## CSP 25-056 AL BP041 – ADDENDUM No.01 HVAC MEP EAST ZONE 3

Fort Bend Independent School District  
2023 Bond Program

Addendum 01

13 August 2025

SO-M2.01

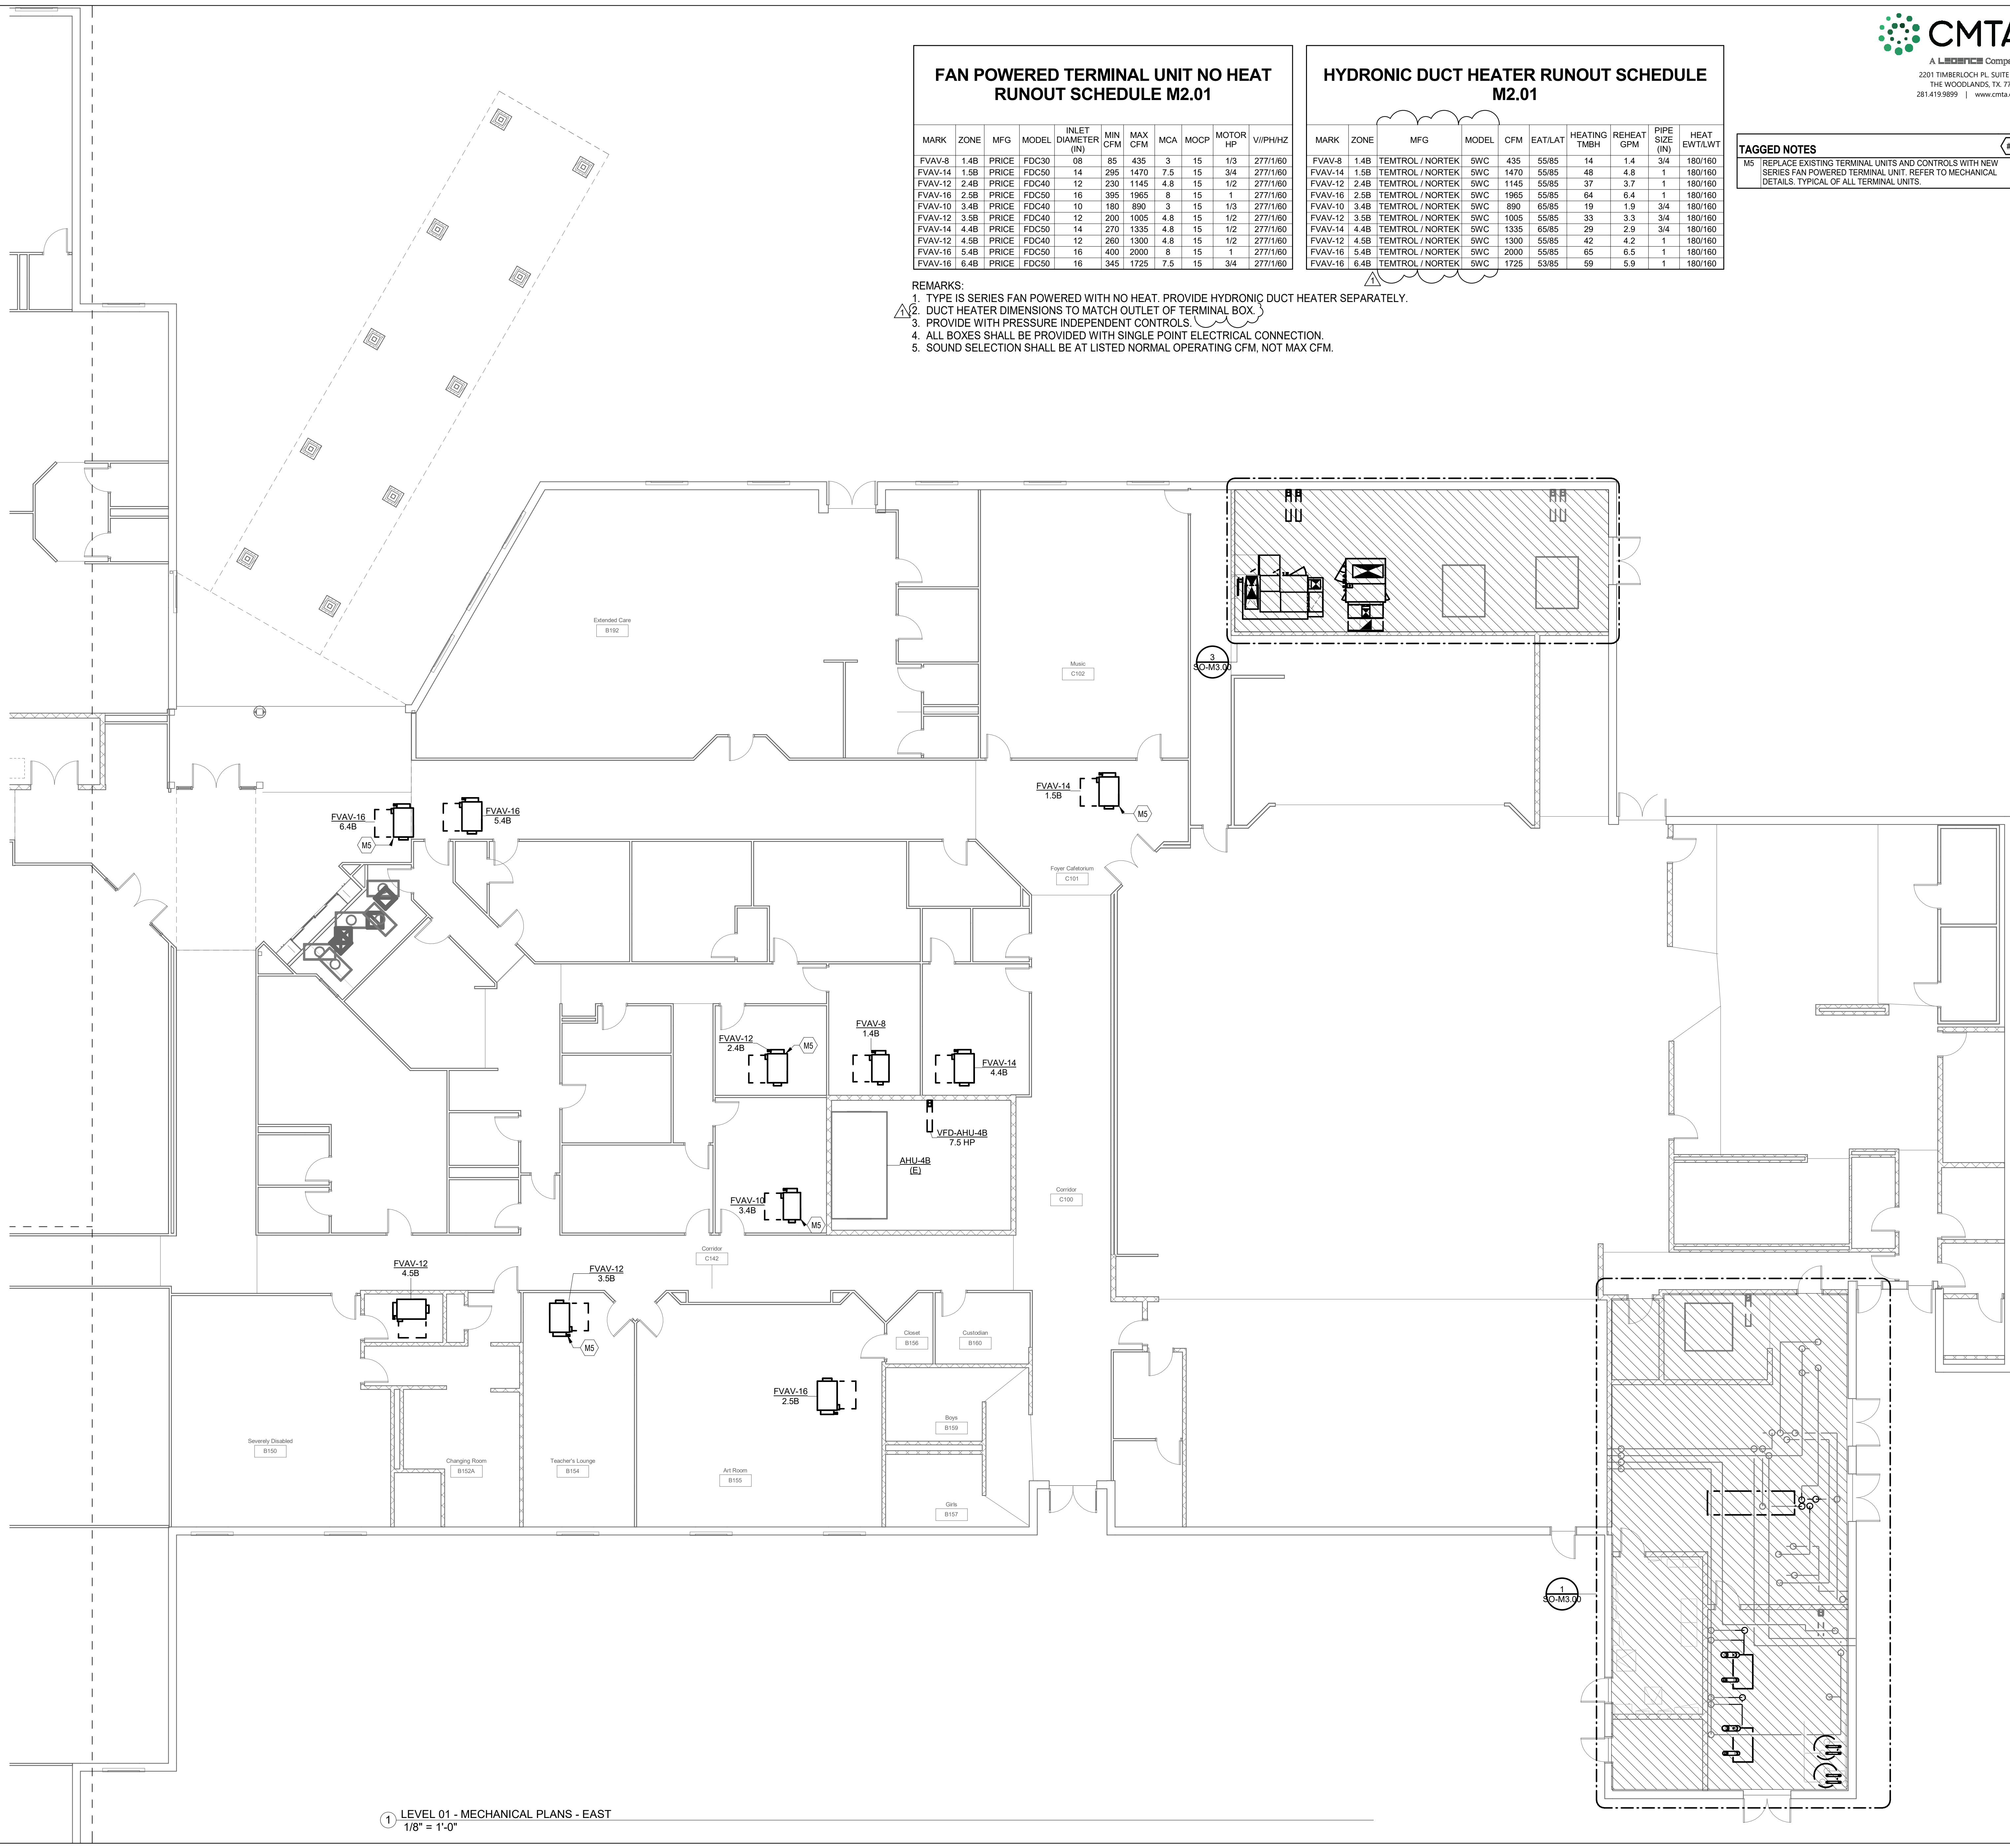
- 10 **Sheet SO-M2.01 – MECHANICAL – EAST**
  - a. Separated hydronic duct heater into separate schedule. Added manufacturer and equipment model of duct heater.

- REMARKS:
1. TYPE IS SERIES FAN POWERED WITH NO HEAT. PROVIDE HYDRONIC DUCT HEATER SEPARATELY.
  2. DUCT HEATER DIMENSIONS TO MATCH OUTLET OF TERMINAL BOX.
  3. PROVIDE WITH PRESSURE INDEPENDENT CONTROLS.
  4. ALL BOXES SHALL BE PROVIDED WITH SINGLE POINT ELECTRICAL CONNECTION.
  5. SOUND SELECTION SHALL BE AT LISTED NORMAL OPERATING CFM, NOT MAX CFM.

HYDRONIC DUCT HEATER RUNOUT SCHEDULE M2.01										
MARK	ZONE	MFG		MODEL	CFM	EAT/LAT	HEATING TMBH	REHEAT GPM	PIPE SIZE (IN)	HEAT EWT/LWT
FVAV-8	1.4B	TEMPROL / NORTEK	SWC	435	55/85	14	1.4	3/4	180/160	
FVAV-14	1.5B	TEMPROL / NORTEK	SWC	1470	55/85	48	4.8	1	180/160	
FVAV-12	2.4B	TEMPROL / NORTEK	SWC	1145	55/85	37	3.7	1	180/160	
FVAV-16	2.5B	TEMPROL / NORTEK	SWC	1965	55/85	64	6.4	1	180/160	
FVAV-10	3.4B	TEMPROL / NORTEK	SWC	890	65/85	19	1.9	3/4	180/160	
FVAV-12	3.5B	TEMPROL / NORTEK	SWC	1005	55/85	33	3.3	3/4	180/160	
FVAV-14	4.4B	TEMPROL / NORTEK	SWC	1335	65/85	29	2.9	3/4	180/160	
FVAV-12	4.5B	TEMPROL / NORTEK	SWC	1300	55/85	42	4.2	1	180/160	
FVAV-16	5.4B	TEMPROL / NORTEK	SWC	2000	55/85	65	6.5	1	180/160	
FVAV-16	6.4B	TEMPROL / NORTEK	SWC	1725	53/85	59	5.9	1	180/160

**SO-M2.02**

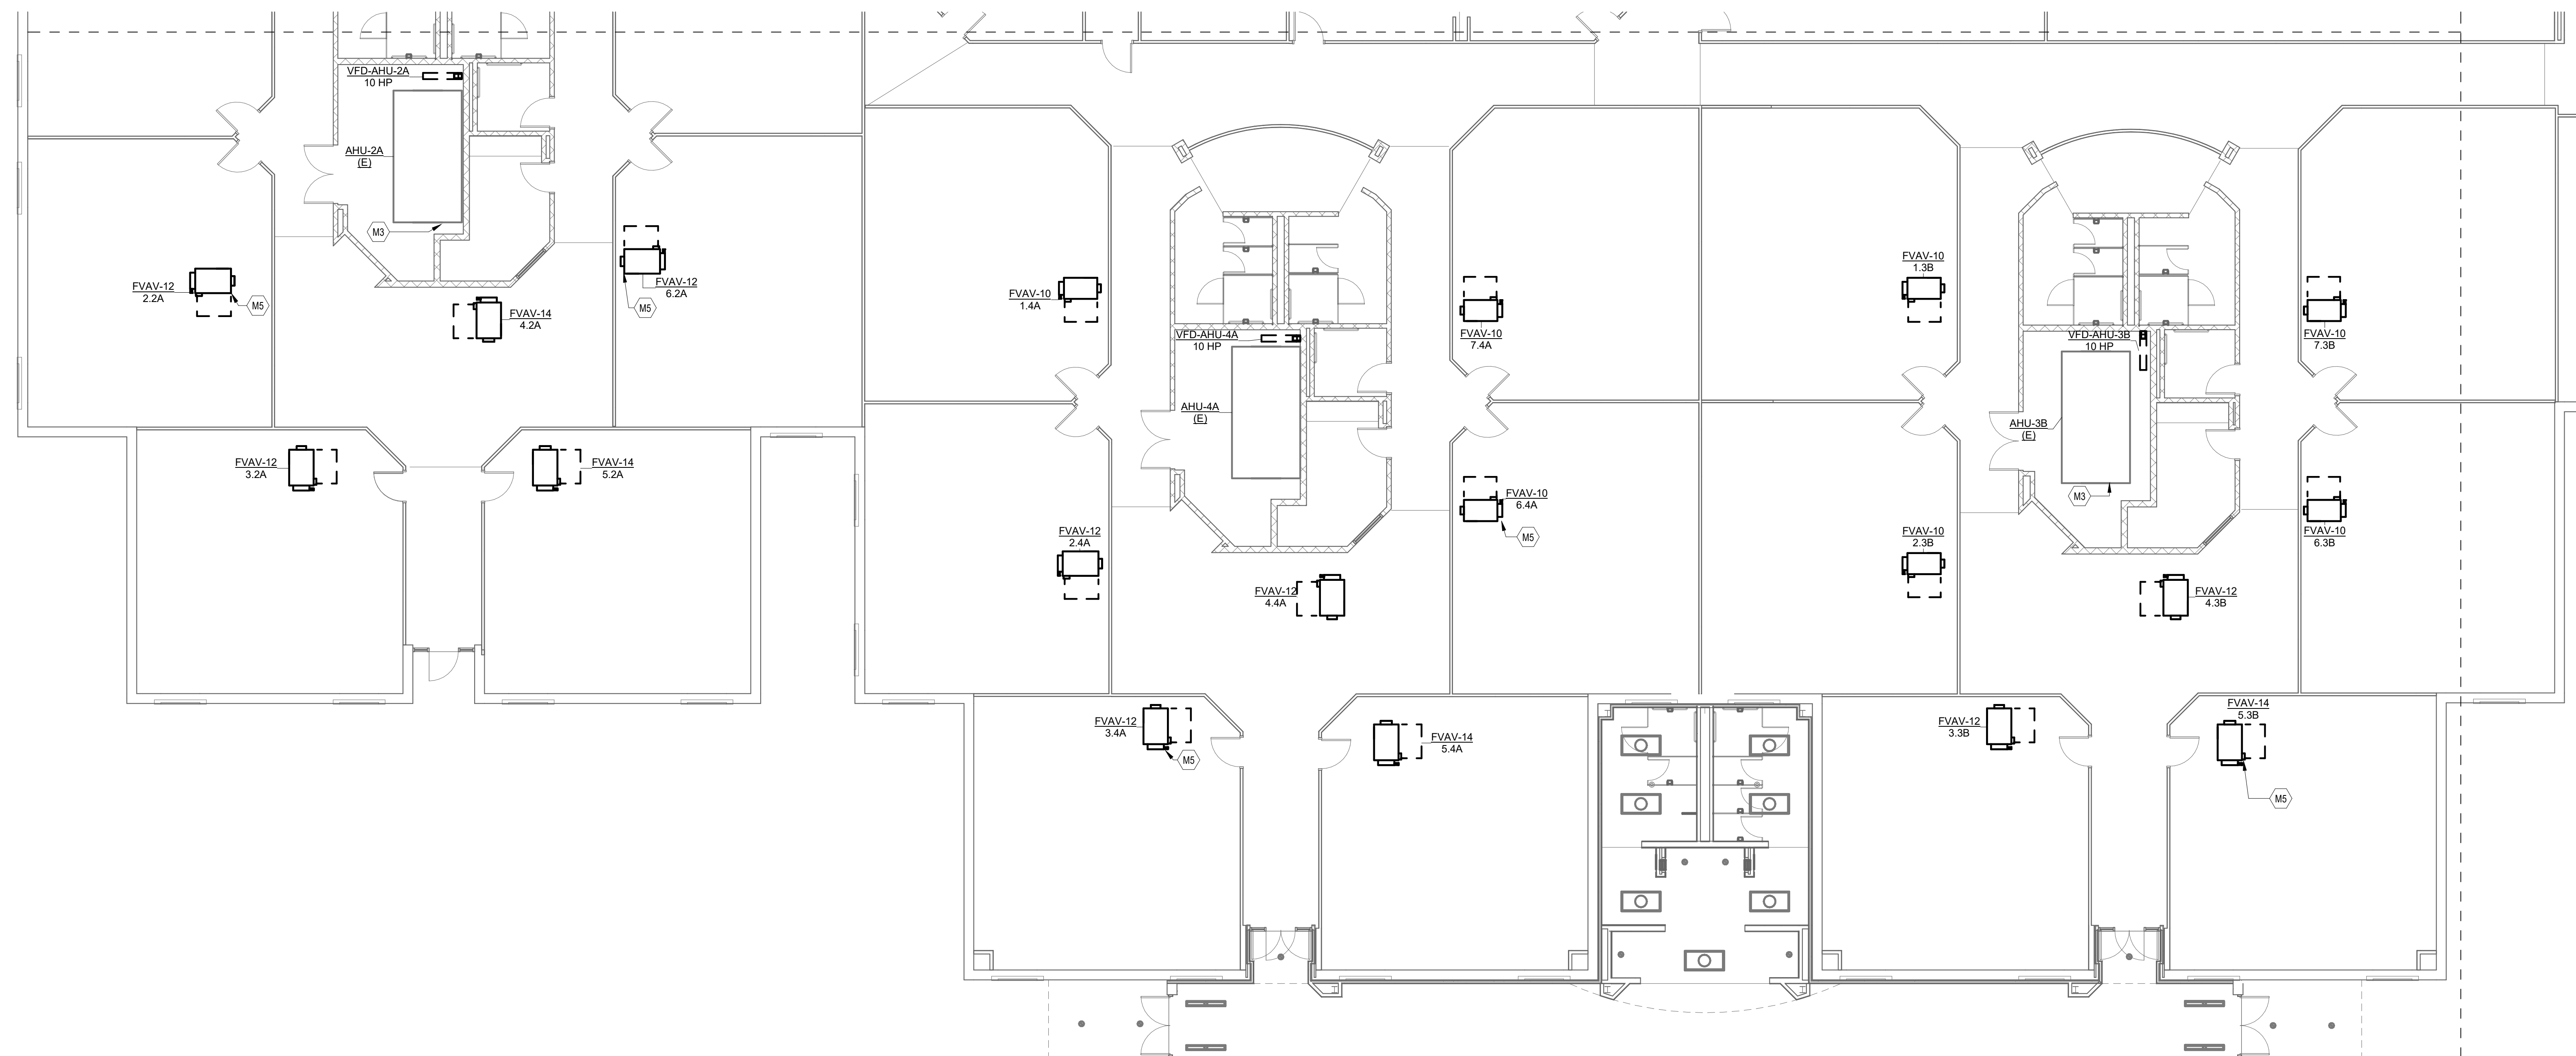
- 11 **Sheet SO-M2.02 – MECHANICAL – SOUTH**
  - b. Separated hydronic duct heater into separate schedule. Added manufacturer and equipment model of duct heater.

1. TYPE IS SERIES FAN POWERED WITH NO HEAT. PROVIDE HYDRONIC DUCT HEATER SEPARATELY.
2. DUCT HEATER DIMENSIONS TO MATCH OUTLET OF TERMINAL BOX. }
3. PROVIDE WITH PRESSURE INDEPENDENT CONTROLS. }
4. ALL BOXES SHALL BE PROVIDED WITH SINGLE POINT ELECTRICAL CONNECTION.
5. SOUND SELECTION SHALL BE AT LISTED NORMAL OPERATING CFM, NOT MAX CFM.

HYDRONIC DUCT HEATER RUNOUT SCHEDULE									
M2.02									
MARK	ZONE	DH MFG	MODEL	CFM	EAT/LAT (DB) (F)	HEATING TIMBH	REHEAT CFM	PIPE SIZE (IN)	HEAT EWT/LAT
FVAV-10	1.3E	TEMPROL / NORTEK	5WC	985	55/85	32	3.2	3/4	180 / 160
FVAV-10	1.4A	TEMPROL / NORTEK	5WC	985	55/85	32	3.2	3/4	180 / 160
FVAV-12	2.2A	TEMPROL / NORTEK	5WC	1220	55/85	40	4.0	1	180 / 160
FVAV-10	2.3B	TEMPROL / NORTEK	5WC	1000	55/85	33	3.3	3/4	180 / 160
FVAV-12	2.4A	TEMPROL / NORTEK	5WC	1260	55/85	41	4.1	1	180 / 160
FVAV-12	3.2A	TEMPROL / NORTEK	5WC	1160	55/85	38	3.8	3/4	180 / 160
FVAV-12	3.3B	TEMPROL / NORTEK	5WC	1160	55/85	38	3.8	1	180 / 160
FVAV-12	3.4A	TEMPROL / NORTEK	5WC	1160	55/85	38	3.8	1	180 / 160
FVAV-14	4.2A	TEMPROL / NORTEK	5WC	1350	55/85	29	2.9	3/4	180 / 160
FVAV-12	4.2B	TEMPROL / NORTEK	5WC	1160	55/85	26	2.6	3/4	180 / 160
FVAV-14	4.4A	TEMPROL / NORTEK	5WC	1230	63/85	27	2.7	3/4	180 / 160
FVAV-14	5.2A	TEMPROL / NORTEK	5WC	1430	55/85	47	4.7	1	180 / 160
